NEW RELEASE MY22

Descriptions and advantages

Always synonymous with excellence, Vittorazi Motors just launched two incredible updates on the market this year: the best seller **Moster185** and the **Atom80**. The newly released engines are ready, the **MY22**.

PICTURE 2 - 3

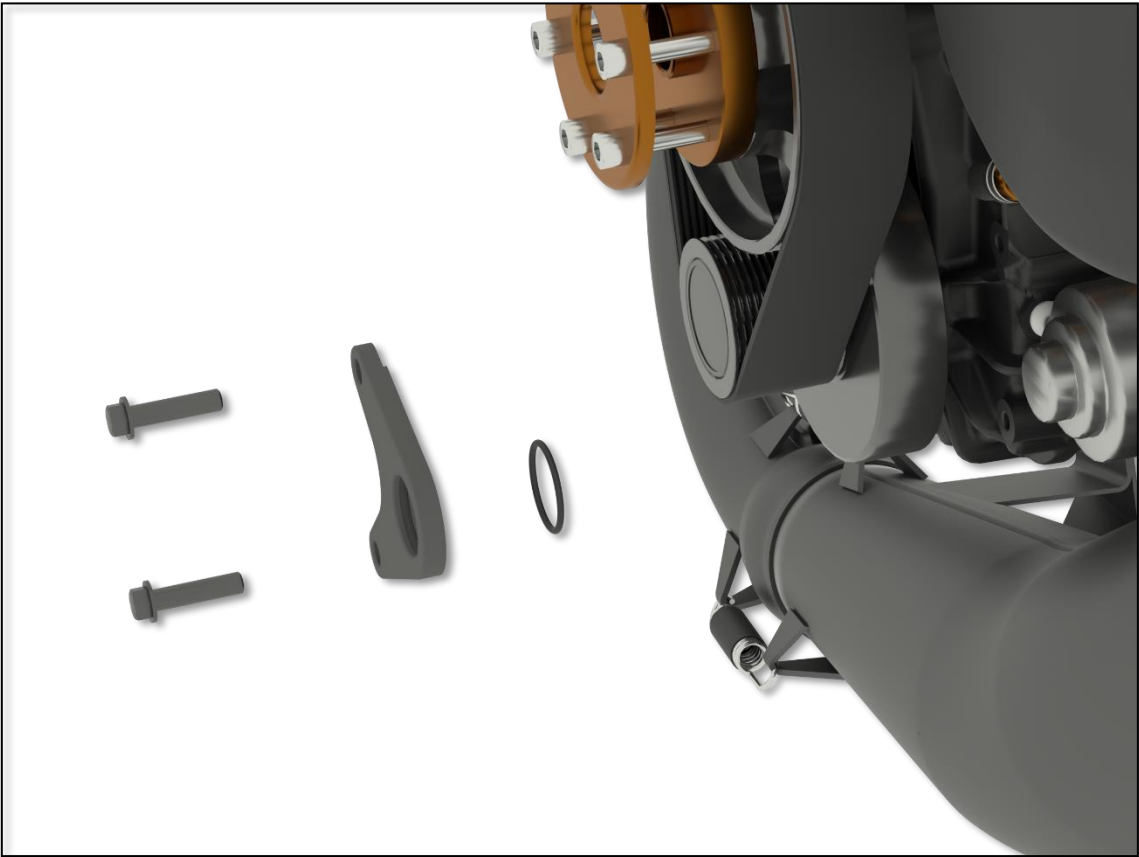
Starting system			
N.	Description	Advantage	Engine model
1	Starter spacers with captive screws	Increased system safety during maintenance	MOSTER185PLUS MOSTER185PLUS DUAL FACTORY-R
2	Starter pin center screw, increased to 8mm	Increased resistance to strong acceleration and impact	MOSTER185PLUS MOSTER185PLUS DUAL FACTORY-R
3	Reinforced starter stud tip	Increased resistance to strong acceleration and impact	MOSTER185PLUS MOSTER185PLUS DUAL FACTORY-R ATOM80
4	Starter motor support plate with O-ring as damper	Higher accuracy, lower noise, longer system life	MOSTER185PLUS DUAL

PICTURE 6 - 7

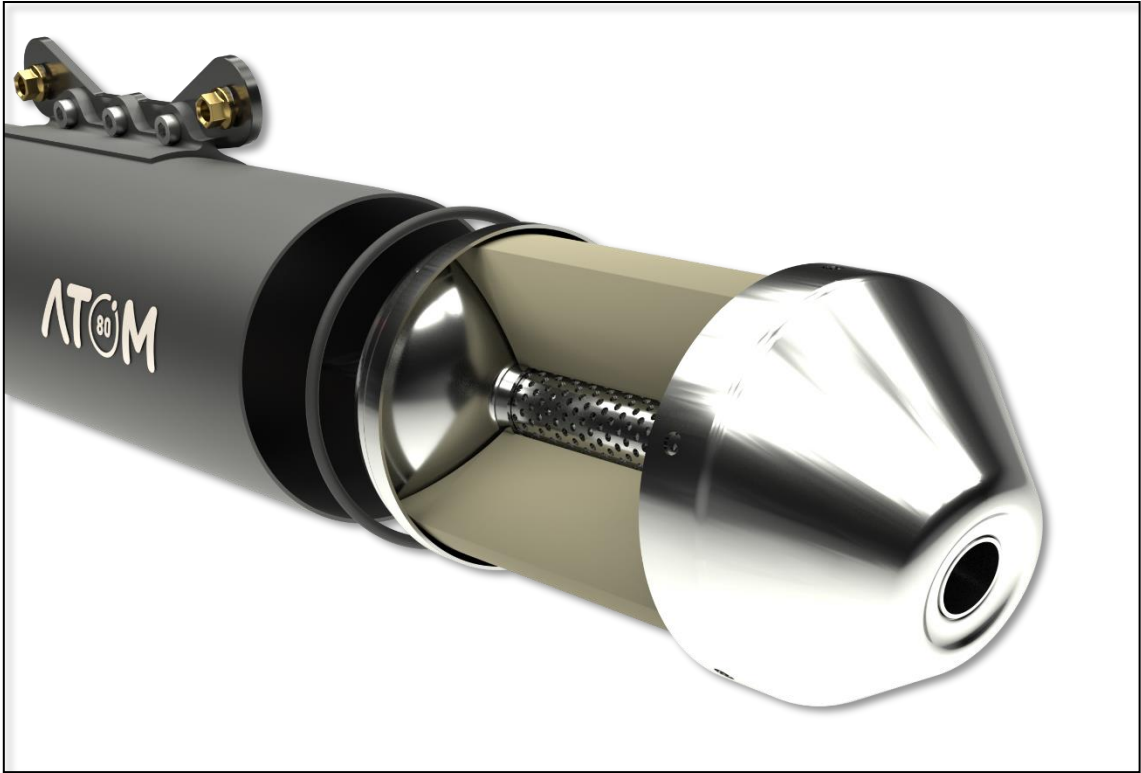
Silencer system			
N.	Description	Advantage	Engine model
5	Reinforced silencer band, with grommet and fixing bushing	Increased system durability and safety during maintenance	MOSTER185PLUS MOSTER185PLUS DUAL
6	Internal silencer mesh with increased thickness	Increased resistance to strong acceleration and impact	MOSTER185PLUS MOSTER185PLUS DUAL FACTORY-R
7	Silencer gasket, new shape	Increased system durability and safety during maintenance	MOSTER185PLUS MOSTER185PLUS DUAL FACTORY-R
8	Added an O-ring gasket to the inner bulkhead of the silencer	Increased durability of the soundproofing material; no discoloration of the silencer; reduced vibrations of the end cap.	ATOM80

PICTURE 9 - 10

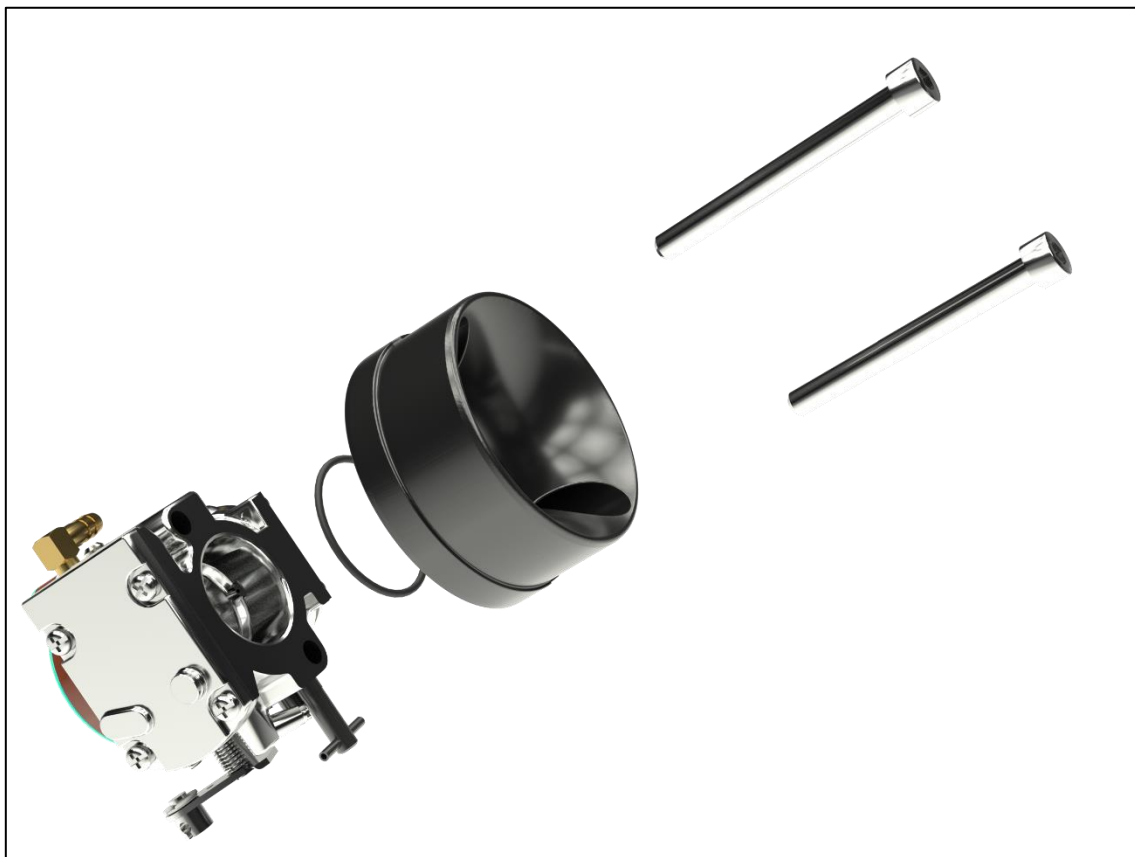
Intake system			
N.	Description	Advantage	Engine model
9	Plastic airbox connector, injection moulded, with metal fixing bushings	Increased component durability and safety during maintenance	ATOM80 MOSTER185PLUS MOSTER185PLUS DUAL
10	Carburetor milling to improve the housing and operation of the shutter spring	Increased safety during regular use	ATOM80 MOSTER185PLUS MOSTER185PLUS DUAL FACTORY-R
